Planning Registration Team
Wiltshire Council
Our reference: 2608
Your reference: 16/10880/FUL
30th April 2026

Amendment Application to Planning Permission 16/10880/FUL: variation of Condition 02 Plans List to substitute car parking layout with revised proposals.

Former Rose & Crown
Middle Stoke, Limpley Stoke,
Bath, Wiltshire
BA2 7GE

839d-LvWH-GEN-A36-DR-GEN-101

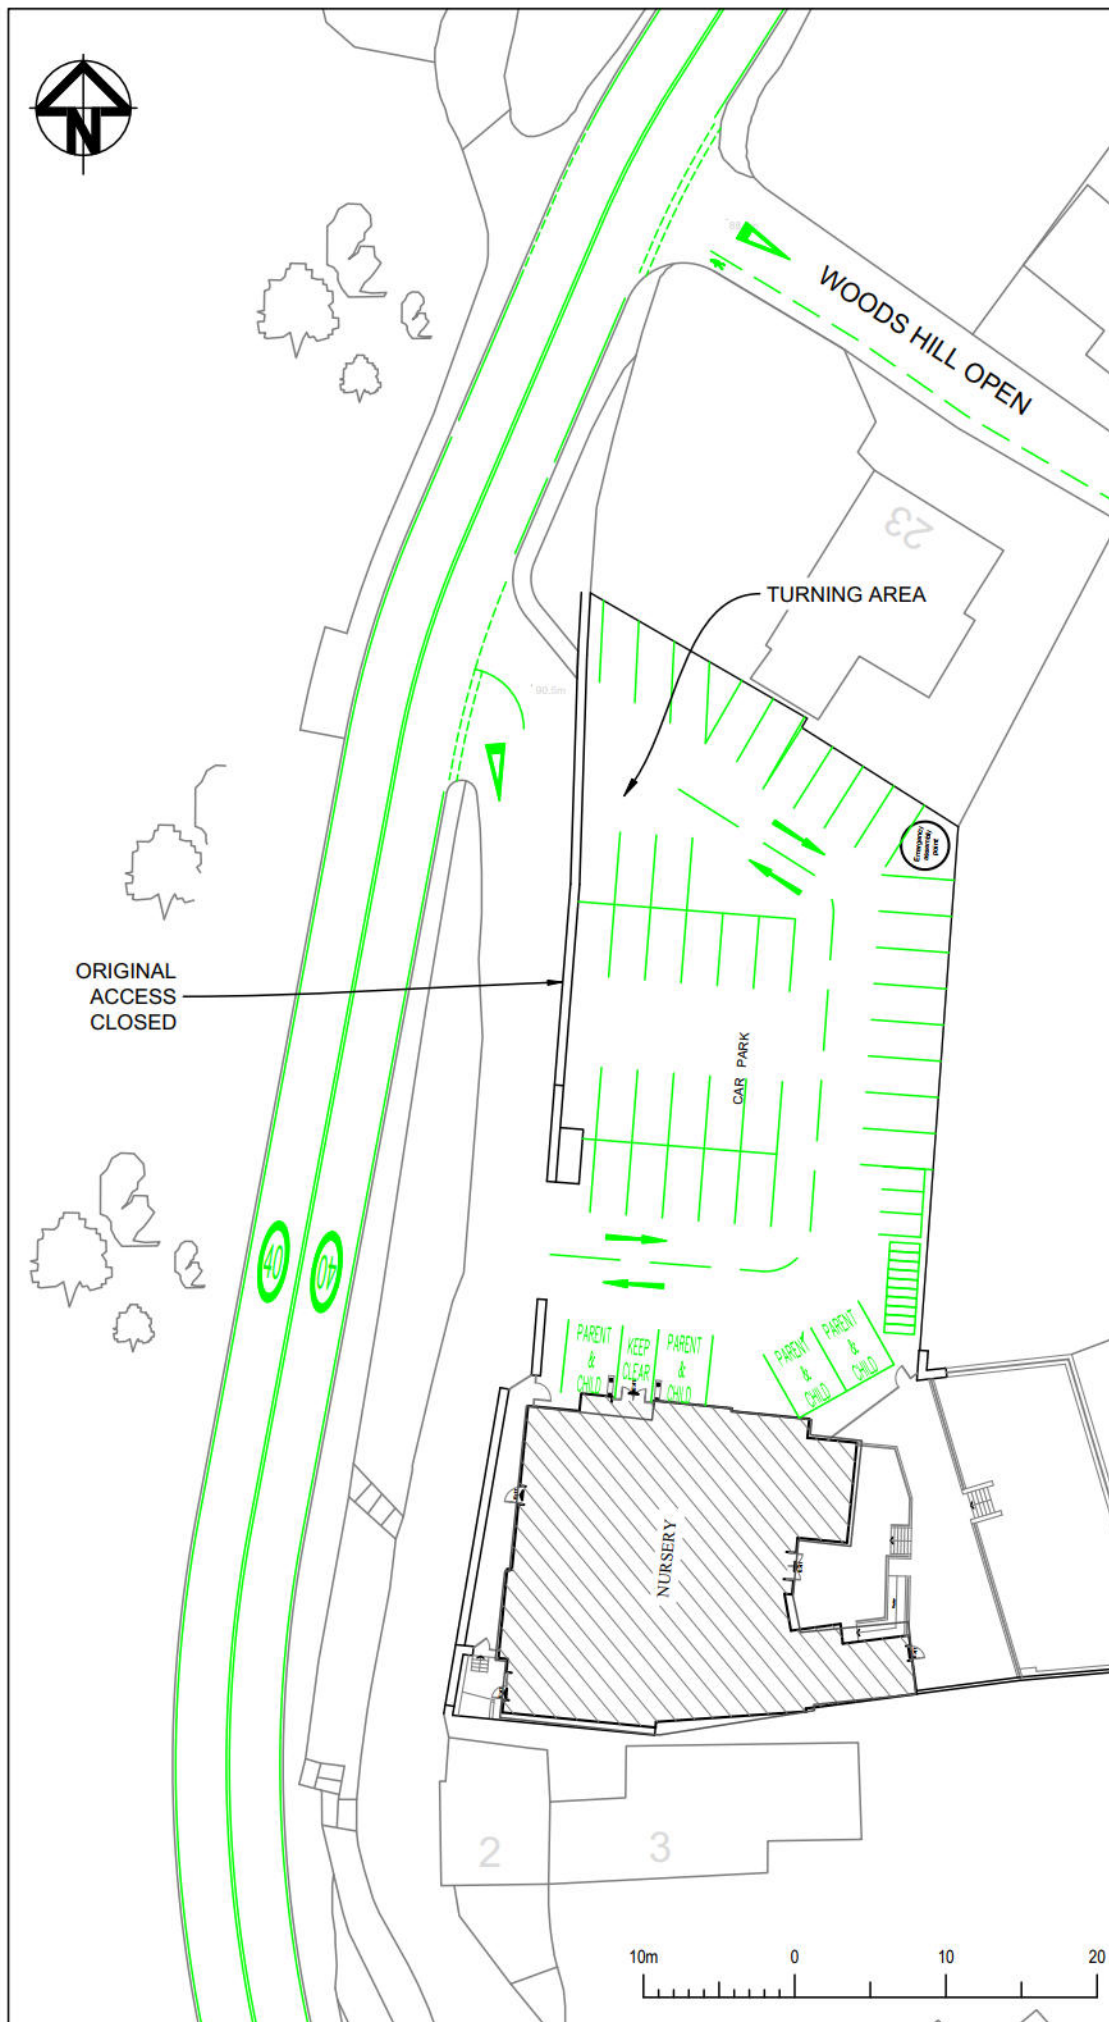
As background information the following layouts have been prepared to illustrate why it is no longer feasible to implement the Approved Nursery & Business Unit Parking Plan

Original Public House car park and access layout: 839c-LvWH-GEN-A36-DR-GEN-101
